SUBJECT: Proposed Revisions and New Specification Sheets (*)

Projects to incorporate New Switches (new dash nos.) for QPL qualification

MIL-DTL-3928/16C
DRAFT
SUPERSEDING
MIL-DTL-3928/16B
15 August 2001

SWITCHES, RADIO-FREQUENCY
TRANSMISSION LINE (COAXIAL) (ELECTRICALLY OPERATED)
CLASS 5, 1P3T

FIGURE 2. Switch configuration and schematic, PIN M3928/16-03.

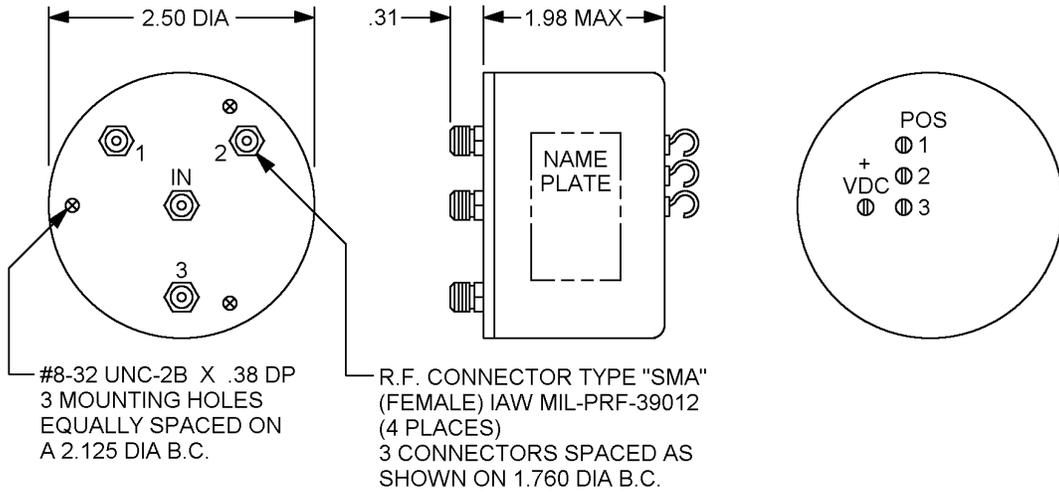
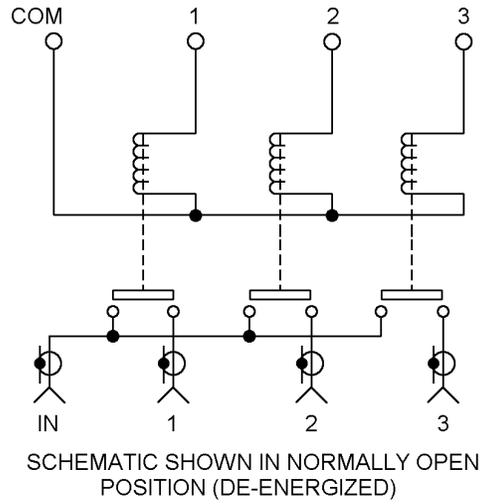
Project	Scope	New Figures
5985-1294 Rev MIL-DTL-3928/10F	Incorporate three new dash nos. -013 -014 -015	Figures 8, 9, 10
5985-1295 Rev MIL-DTL-3928/15F	Incorporate three new dash nos. -017 -018 -019	Figures 12, 13 14
5985-1296 Rev MIL-DTL-3928/16C	Incorporate new dash no. -03	Figure 2
5985-1297 Rev MIL-DTL-3928/17C	Incorporate new dash nos. -04 -05 -06	Figures 4, 5, 6
5985-1298 Rev MIL-DTL-3928/18D	Incorporate new dash no. -09.	Figure 9
5985-1300 New MIL-DTL-3928/26	New specification sheet w/ dash nos. -01 -02	Figures 1, 2
5985-1301 New MIL-DTL-3928/27	New specification sheet w/ dash nos. -01 -02	Figures 1, 2
5985-1302 New MIL-DTL-3928/28	New specification sheet w/ dash no. -01.	Figure 1
5985-1299 Rev MIL-DTL-3928F Supplement 1	Incorporate new specification sheets /26, /27, /28; is new supplement for revised basic specification.	N/A

RF power handling capability (average): 25 watts (minimum); for dash -03, power max = 100 watts cw.
